# UNITED STATES PATENT AND TRADEMARK OFFICE

APPLICATION NO.	FILING DATE	FIRST NAMED INVENTOR	ATTORNEY DOCKET NO.	CONFIRMATION NO.
10/811,064	03/26/2004	David B. Gill	3962 P 028	8082
7590	05/10/2006	PAUL J. NYKAZA, ESQ. WALLENSTEIN WAGNER & ROCKEY, LTD. 53RD FLOOR 311 SOUTH WACKER DRIVE CHICAGO, IL 60606-6630		
		EXAMINER LUGO, CARLOS		
		ART UNIT 3676	PAPER NUMBER	
		DATE MAILED: 05/10/2006

<b>Office Action Summary</b>	<b>Application No.</b>	<b>Applicant(s)</b>	
	10/811,064	GILL, DAVID B.	
	<b>Examiner</b>	<b>Art Unit</b>	
	Carlos Lugo	3676

## DETAILED ACTION

Attachment #1

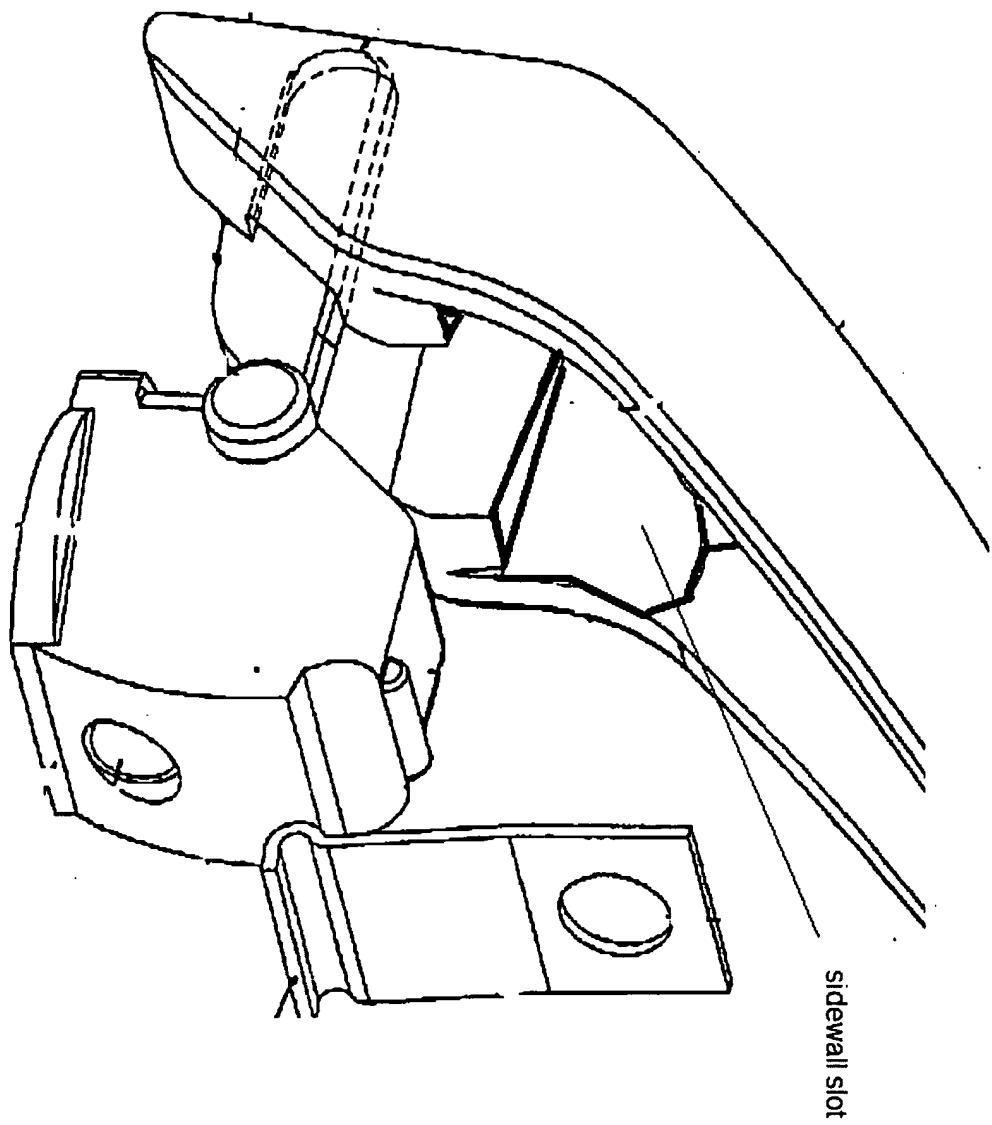
The operator further comprises a handle (10) having a base and a pair of sidewalls extending from the base so as to define a cavity (17). The base has a top and a bottom surface generally oppose to the top surface (see attachment #1).

A handle (10) pivotally connected to the arm; the handle having a base and a pair of sidewalls defining a cavity. The base has a top and a bottom surface generally oppose to the top surface (see attachment #1). The base also has a peg (30) extending into the cavity and each sidewall includes a slot (see attachment #2).

The operator further comprises a handle (10) having a base and a pair of sidewalls extending from the base so as to define a cavity (17). The base has a top and a bottom surface generally oppose to the top surface (see attachment #1). Each sidewall includes a slot (see attachment #2).

As to the arguments presented by the applicant that Harvey fails to disclose that the leaf spring is positioned between the sidewalls and having a surface generally confronting the bottom surface of the base and an opposite surface generally confronting the arm (Page 11 Line 26), Harvey clearly discloses and illustrate this limitation (see attachments #1 and #2). Therefore, the rejection of the claims in view of Harvey is maintained.
